### MAJOR PROJECT PUBLIC NOTICE STATE AGENCY NOTICE OF INTENT RECEIVED APA PROJECT NO. 2022-0242

The project is briefly described as follows: **Installation of a temporary "cell on wheels" at an existing NYS Department of Transportation maintenance yard from 12/1/22 to 2/7/23, during the World University Games. The proposed "cell on wheels" consists of a truck with a telescoping tower, to support Verizon Wireless antennas at 60 feet above ground level.**

### STATE AGENCY PROJECT PUBLIC NOTICE 814 ORDER NOTICE OF INTENT COMPLETED APA PROJECT No. 2022-0242

## RESPONSE TO APA APPLICATION FOR TELECOMMUNICATIONS TOWER SUPPLEMENTAL INFORMATION REQUEST

ELEVATION VIEW  
SECTION 'A'

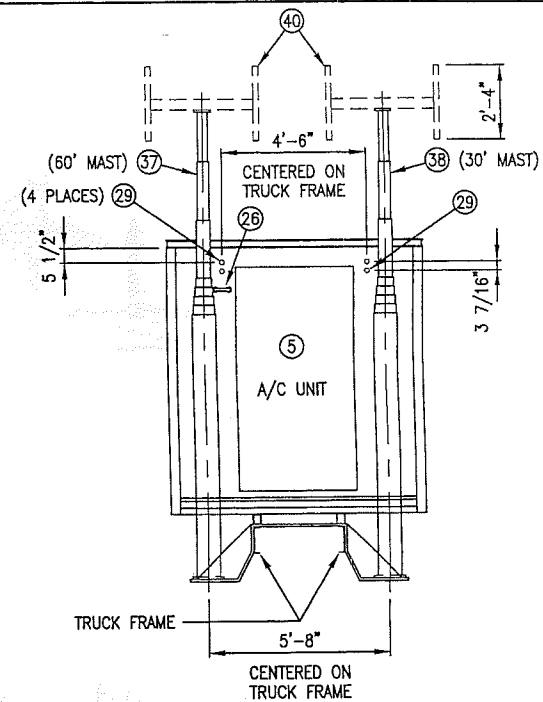
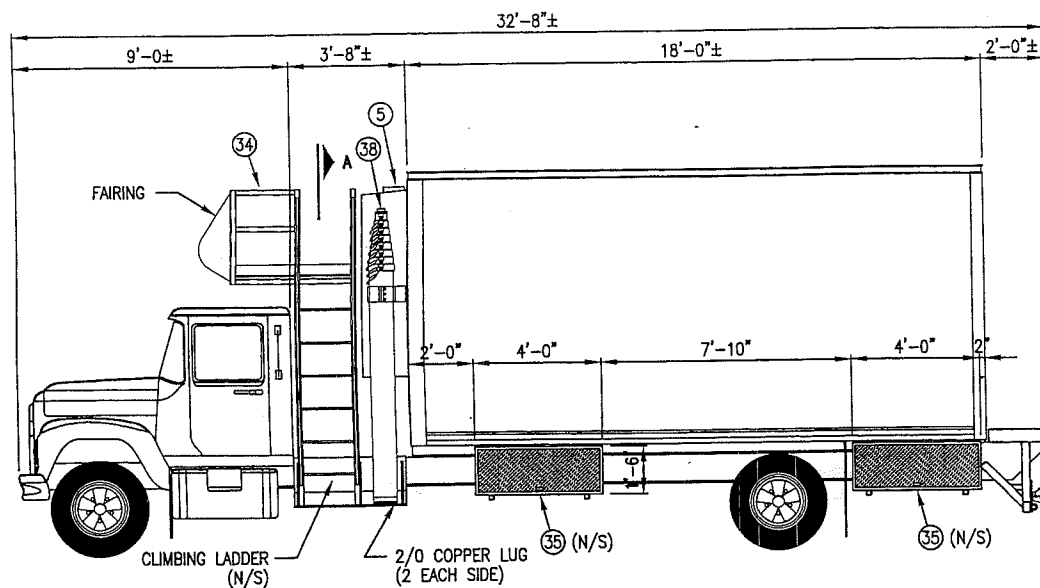
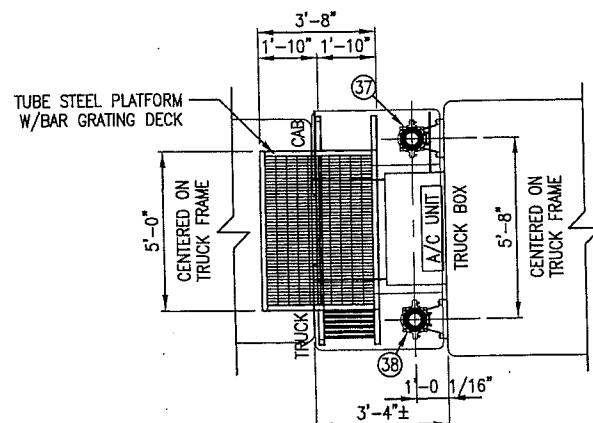
The COW Specifications at Attachment B show the truck is equipped with both a 60-foot mast and a 30-foot mast. From the narrative responses in the SIR, it sounds like Verizon Wireless only has plans to use the 60-foot mast. Is that accurate? Would the 30-foot mast remain un-extended, as shown in the Elevation Drawing?

Please provide an elevation drawing or a photograph that shows how the COW set up looks with the 60-foot mast extended.

Ariel, you are correct. Only the 60-foot mast will be raised. We will provide the elevation as well.  
Thank you for starting review of this project.  
Jacqui
